**FINDINGS AND RECOMMENDATION
OFFICE OF PLANNING AND ZONING
ANNE ARUNDEL COUNTY, MARYLAND**

CASE NUMBER: 2023-0139-V

The applicants are requesting variances to allow a dwelling and associated facilities with less setbacks and buffer than required and with greater coverage by structures than allowed on property located at 10 West Severn Ridge Road in Annapolis.

VARIANCE PLAN
BROWNS POND ~ LOT 2
10 WEST SEVERN RIDGE ROAD, ANNAPOLIS, MD 21409
TAX ACCT. NO. 03-00042175980 - PARCEL NO. T0350024
TAX MAP 0048 GRID 0007 PARCEL 0022 DISTRICT 3RD
JANE ARONDEL COUNTY MARYLAND

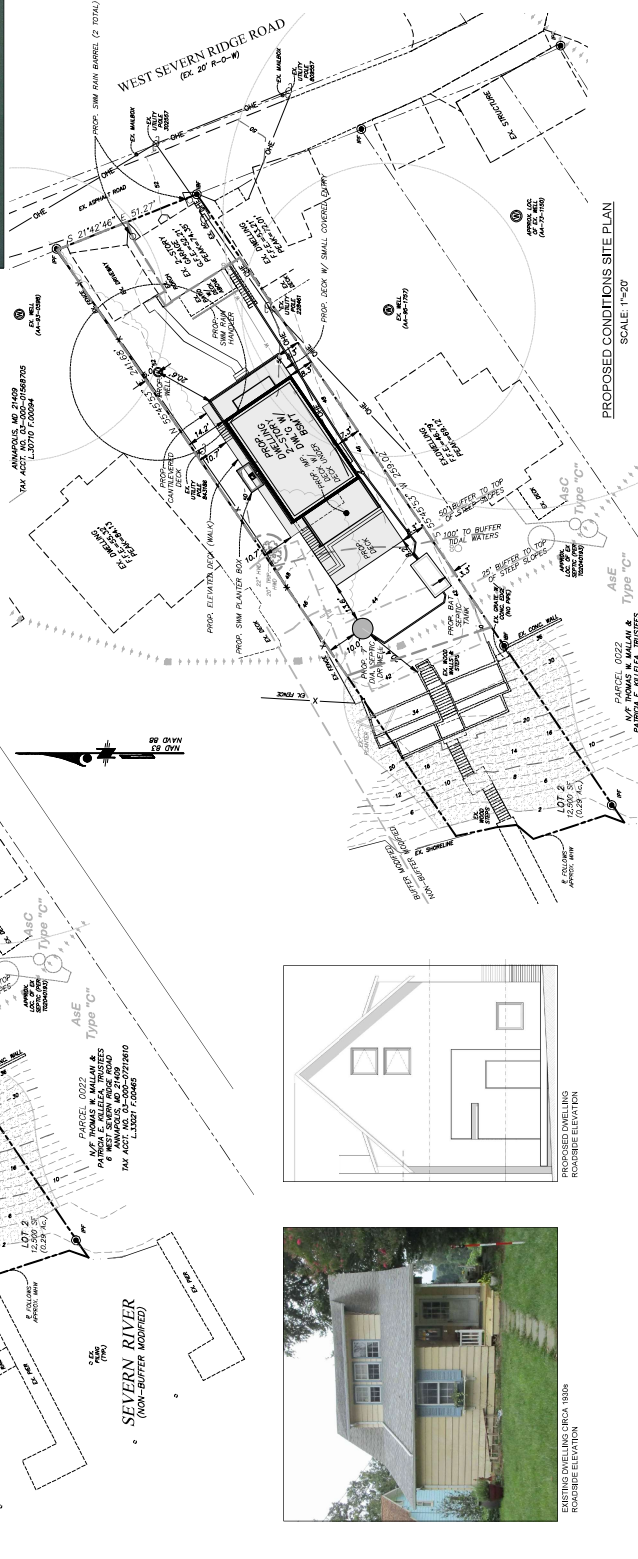
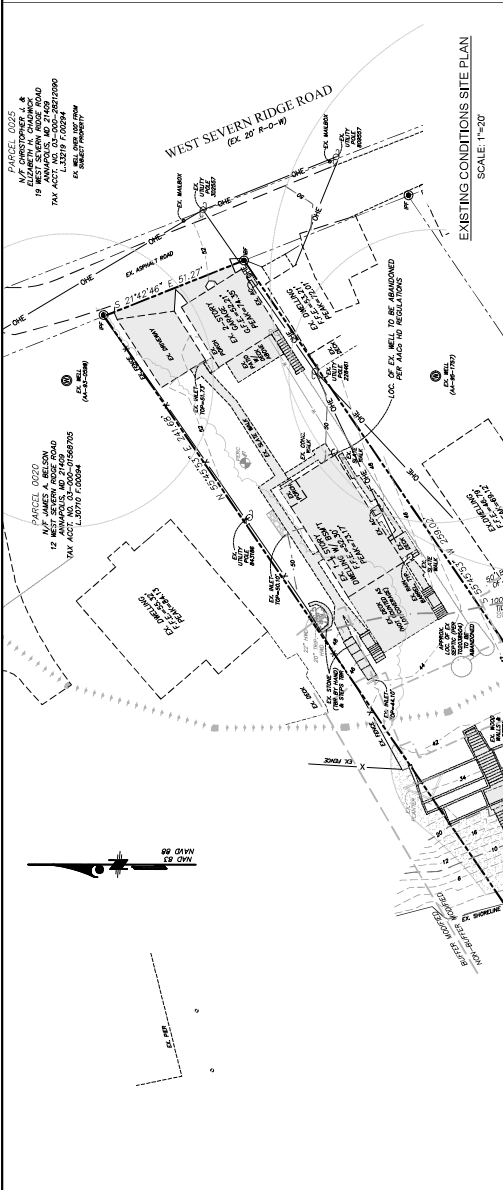
§ 18-4-501 provides that a principal structure in an R1 District shall be set back a minimum of 15 feet from each side lot line. The proposed dwelling would be located 8.3 feet from the south side lot line and 10.7 feet from the north side lot line, necessitating variances of seven feet and five feet, respectively.

§ 18-4-501 requires a minimum 40-foot combined side setback for principal structures. The proposed combined principal structure side setback is 19 feet, necessitating a variance of 21 feet.

§ 18-4-501 also limits the maximum coverage by structures in an R1 District to 25% (or 3,125 square feet in this particular case). The proposed coverage by structures would be 25.52% (or 3,190 square feet), necessitating a variance of 0.52%.

§ 18-2-301(b) provides that an architectural feature that does not contain floor area may extend no more than three feet into a required setback. The proposed chimney would project 7.7 feet into the required 15-foot setback, necessitating a variance of five feet to the maximum three foot projection allowance.

However, the applicant has not demonstrated any practical difficulties or unnecessary hardship or that the coverage by structures variance is necessary. While this Office recognizes that the lot is undersized for the R1 District and that the maximum coverage limitation is based on a larger

anticipated lot area, that alone does not justify a variance. The allowable 3,125 square feet of coverage by structures is ample to allow for reasonable residential use and development. With only a 65 square foot overage, the coverage by structures could be easily reduced with just a small reduction of one of the various decks (or elsewhere) in order to comply with the limitation. As such, the coverage variance is not warranted and cannot be supported.

1. An existing and proposed drainage area map with drainage arrows and detailed grading of how drainage on the side of the proposed home will be conveyed to the back is required.
2. Provide SWM report and computations to show how the ESDv is met for the site.
3. The applicant must confirm the market availability of rain handlers or propose an acceptable roofing system that drains via sheet flow.
4. Photos and professional statements confirming the stability of the steep slopes are required.

- ***Approval*** of a critical area variance to § 17-8-301 to allow construction of a dwelling with approximately 2,807 square feet of disturbance within the buffer.

- ***Approval*** of a zoning variance to § 18-4-501 of seven feet to the minimum 15-foot side setback requirement to allow the proposed dwelling to be constructed 8.3 feet from the south side lot line.

- ***Approval*** of a zoning variance to § 18-4-501 of five feet to the minimum 15-foot side setback requirement to allow the proposed dwelling to be constructed 10.7 feet from the north side lot line.

- ***Approval*** of a zoning variance to § 18-4-501 of 21 feet to the minimum 40-foot combined side setback requirement to allow the proposed dwelling to be constructed with only a 19-foot combined side setback.

- ***Approval*** of a zoning variance to § 18-2-301(b) of five feet to the maximum three-foot projection allowance for an architectural feature to allow the proposed chimney to be constructed 7.3 feet from the south side lot line.

- ***Denial*** of a zoning variance to § 18-4-501 of 0.52% to the maximum 25% coverage by structures limitation.
